Declaration of changes

Differences between the items				Note
Model Name	TA-1448	N1530DL	TA-1476	
GSM:	850, 900, 1800, 1900	850, 900, 1800, 1900	850, 900, 1800, 1900	1、 PCB is the same, PCBA is different; Because of the different frequency band, part of the inductance capacitance is also different; and the performance of the same frequency band is not affected 2、 N1530DL product is the same as TA- 1476 except for the model name.
3G UMTS (WCDMA) :	B1,B 2,B 4, B5,	B2, B4, B5	B2, B4, B5	
LTE Bands:	B1, B2, B3, B4, B5, B7, B8, B12, B13, B17, B20, B25, B26, B38, B39, B40, B41, B66, B71	B2, B4, B5, B12, B13, B25, B26, B41,B66, B71	B2, B4, B5, B12, B13, B25, B26, B41 B66, B71	
NR bands	n71, n66, n25, n41,n77	n2, n5, n66, n77, n71, n25, n41	n2, n5, n66, n77, n71, n25, n41

The different components locations are as below

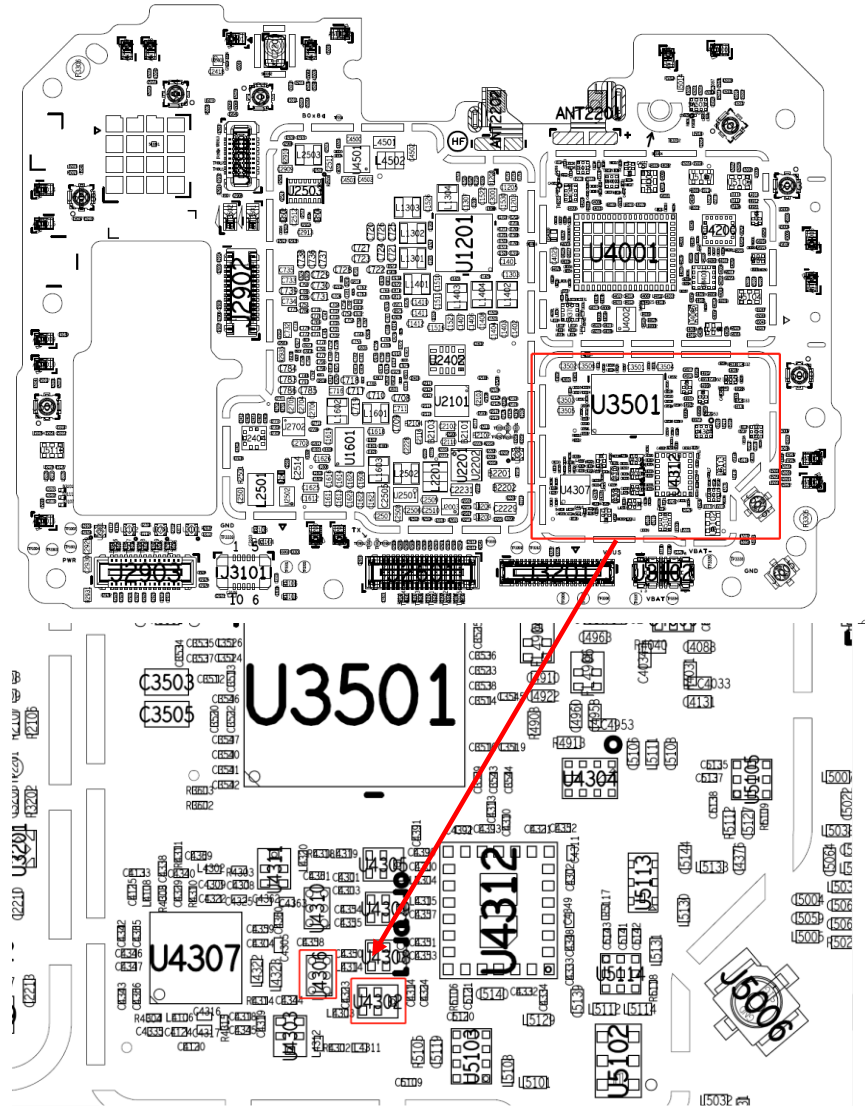
2AJOTTA-1448 :have the components U4302 and U4306; 2AJOTTA-1530and 2AJOTTA-1476: not have the components U4302 and U4306 ; the other components of the three SKUs are same;

1.N1530DL and TA1448 share a PCB and there is a difference on the frequency band, hence U4302/U4306 Band20 related items will be removed from BOM, U4302 is saw for B20, U4306 is swith for B20, Does not affect rf performance except for B20
